NEA/RWM/PEER(2012)2

THE POST-CLOSURE RADIOLOGICAL SAFETY CASE FOR A SPENT FUEL REPOSITORY IN
SWEDEN

An international peer review of the SKB license-application study of March 2011 (Final report)

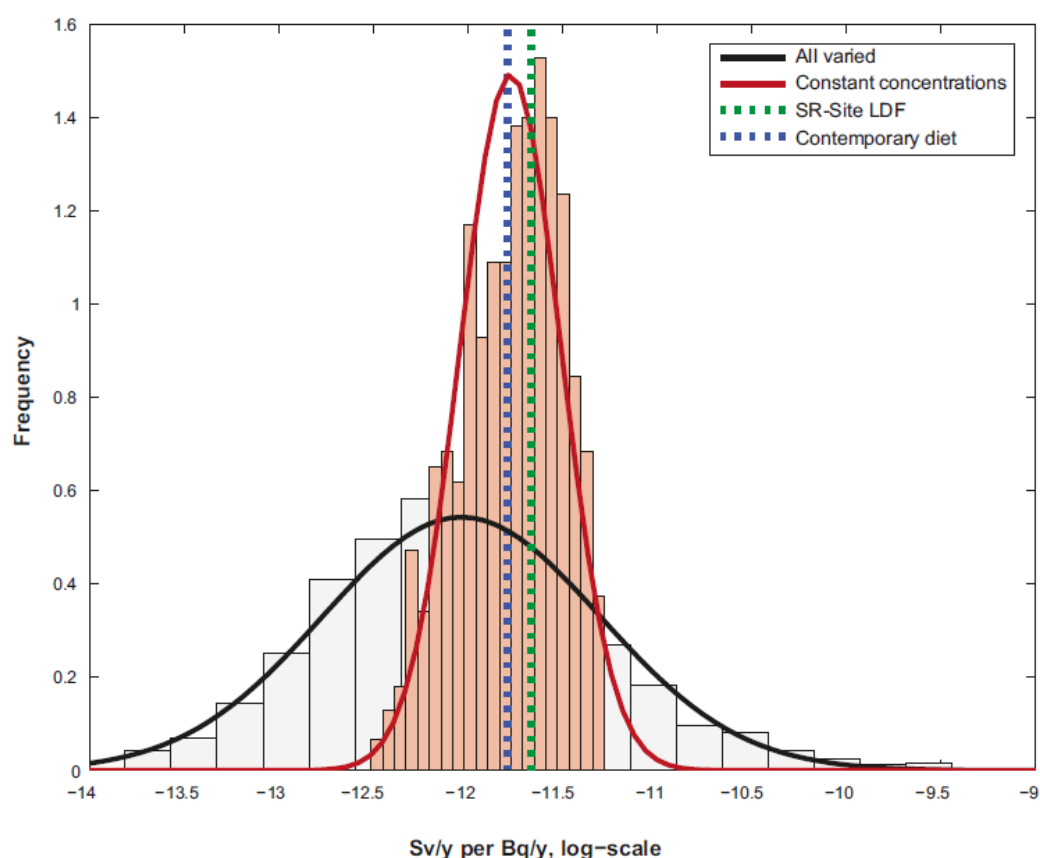
However, SKB notes that use of literature data “clearly exaggerate the uncertainty of Ra-226 retention at the site”. Thus, SKB decided to use the uncertainty in the Ra-226 K_d estimated from the site data in the probabilistic simulations that addressed the effect of parameter uncertainty. The resulting LDF uncertainty spans several orders of magnitude as shown in the figure below (Figure 12-3 reproduced from TR-10-09). Given the importance of Ra-226 in the SKB assessment, and the lack of site-specific data for K_d values for Ra-226, the IRT encourages SKB to attempt to provide better site-specific data for future assessments if at all possible. SKB should also consider that such a large uncertainty in the Ra-226 LDFs could mean that better data would result in some other radionuclide or radionuclides dominating the overall dose rate to the most exposed group. This further underscores the usefulness of obtaining additional, site-specific data for Ra-226.

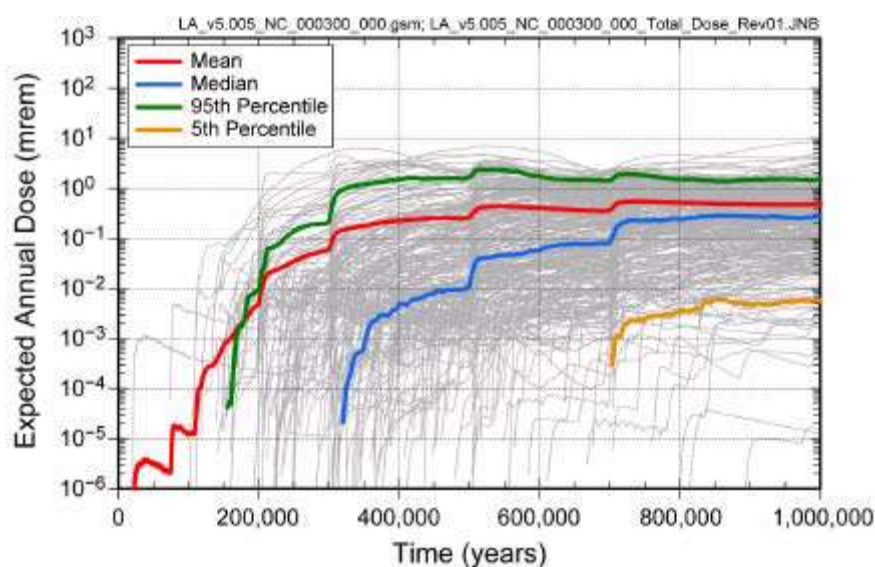
The evaluation of scenarios allows for the calculation of a dose and risk summation, and the conclusions whether the regulatory risk criterion is fulfilled. The risk dilution issue is addressed in a rigorous manner (TR-11-01, chapter 13.9.4): SKB explicitly considers the case of short term releases and calculates an "accumulated short-term risk", following the method suggested in Appendix 1 to SSMFS 2008:37. The result is below the risk limit.

Although the dose calculation based on the technical conclusions drawn from scenarios analyses is sound, the IRT submits the following comment on the presentation of the result: The risk summation curve presents pulse-like features and this is actually an artefact due to the small number of realisations leading to canister failure. Although this does not have any consequence for the demonstration of risk compliance, it is a weakness with respect to the clarity of the demonstration for two reasons:
